THE POINT, 217 KUPE STREET
MISSION BAY, AUCKLAND

Appendix G– Healthy Waters and Watercare Correspondence

Council Resource Consent number PRR00042540
217 Kupe ST Orakei 1071
Watercare application number – RC- 298839

Council Feedback – Infrastructure Report

Dwg No:
22064-C935

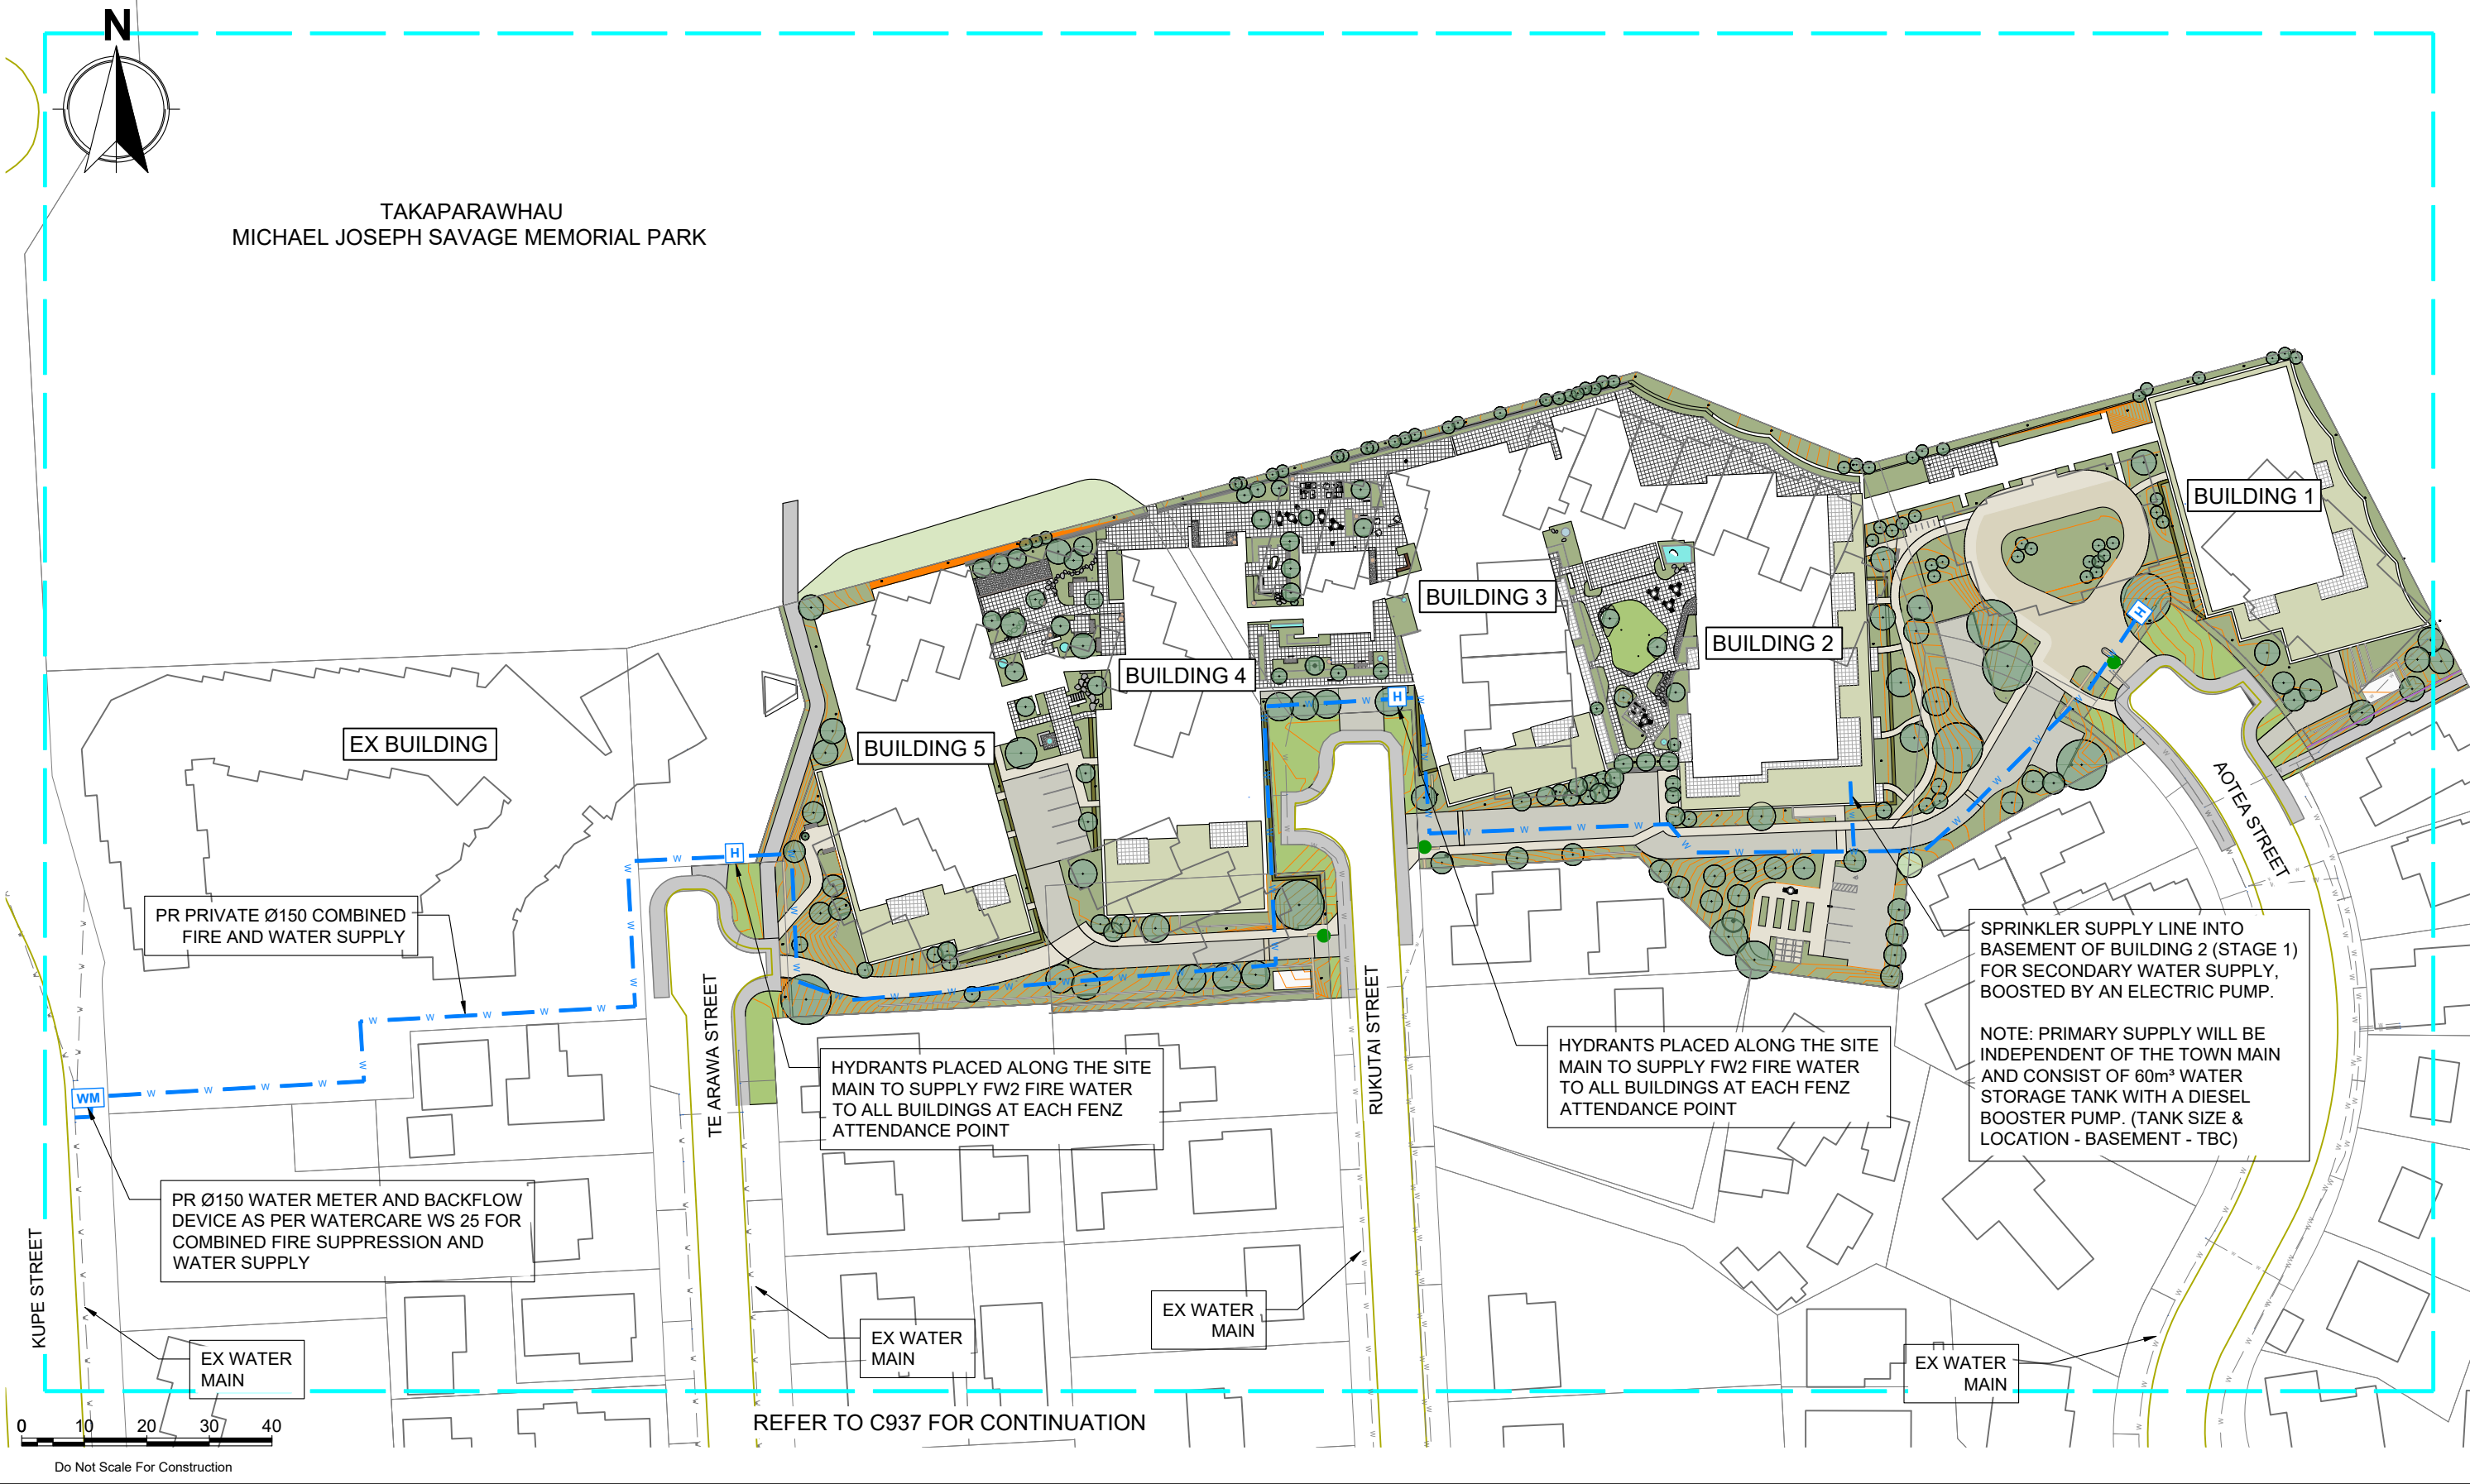
- As the project is an apartment building, Watercare has assumed that the developer will install an on-site tank or a tank-and-pump system to meet the sprinkler requirements, if there are any. Please confirm on that.

Yes, 60m3 of Water storage with diesel booster pumps is proposed. Refer CLC Drawings 22064-C935 Rev A

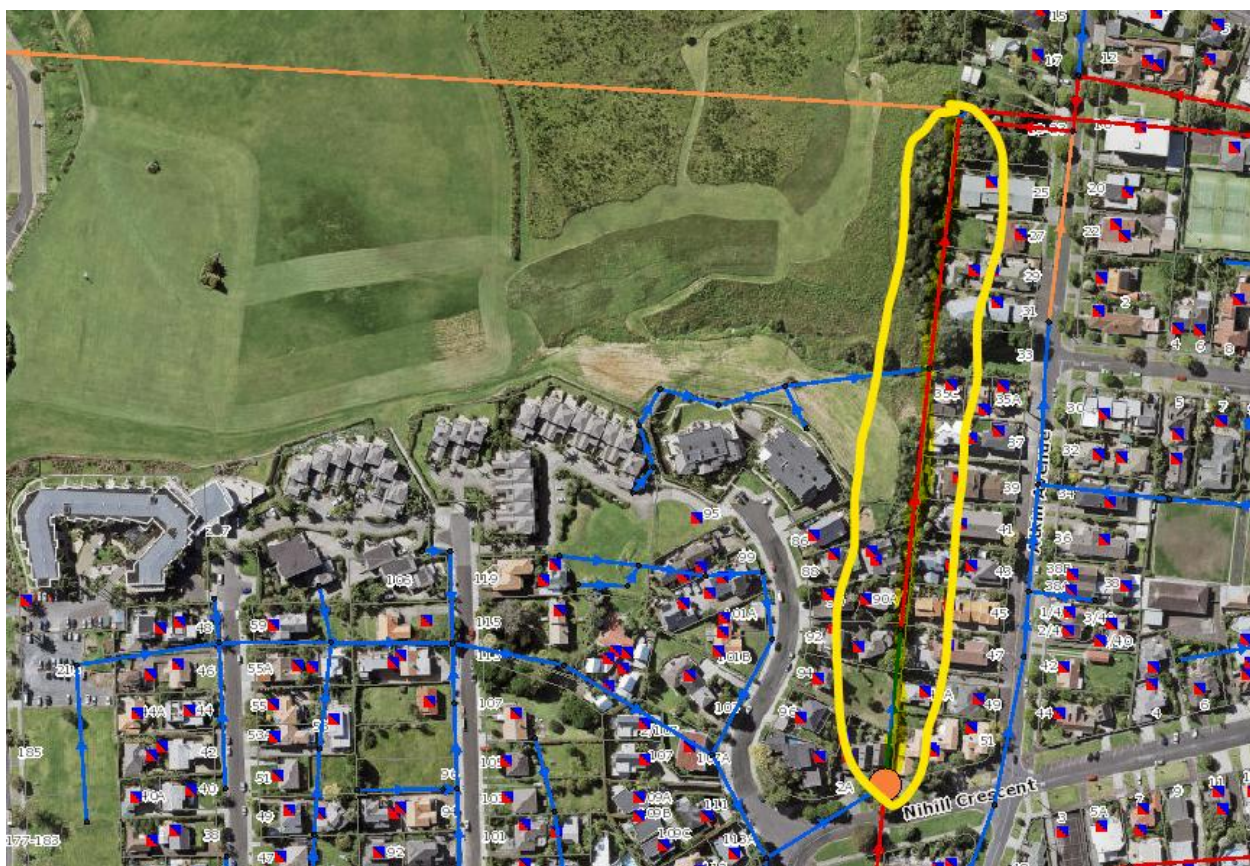
1. **There are constraints in Watercare's wastewater network at the time of this assessment** to accommodate the proposed **252 new Independent Living Units (ILUs) within the five new buildings - East Cliffe Retirement Village**. The following outcome of the application review is addressed:
 - a. There are current capacity constraints in the local network, particularly along the 450 mm wastewater line between Nihill Crescent and the 900mm Mission Bay transmission line.
 - b. These constraints are resulting in overflows at the upstream end of the line (WWMH with GID ID: 532465).
 - c. While the transmission line itself has available capacity (as reflected in the Watercare capacity constraints GIS map), the local network limitations are preventing additional flows from being accommodated at this stage.

As such, we are unable to accept any further volume into this section of the network in its current state, as this would increase the risk of further overflows.

- d. Upgrading the existing sewer pipe to a larger size (which is currently 450mm gravity main from WWMH 532465 to WWMH 514583)
- or,
- e. Constructing additional sewer infrastructure/connection to increase capacity to the transmission line.
- f. Additionally, identifying and removing any stormwater that may be incorrectly connected to the foul sewer, would improve overall network performance.

The below is an indicative mark up of the upgradation required for the existing infrastructure
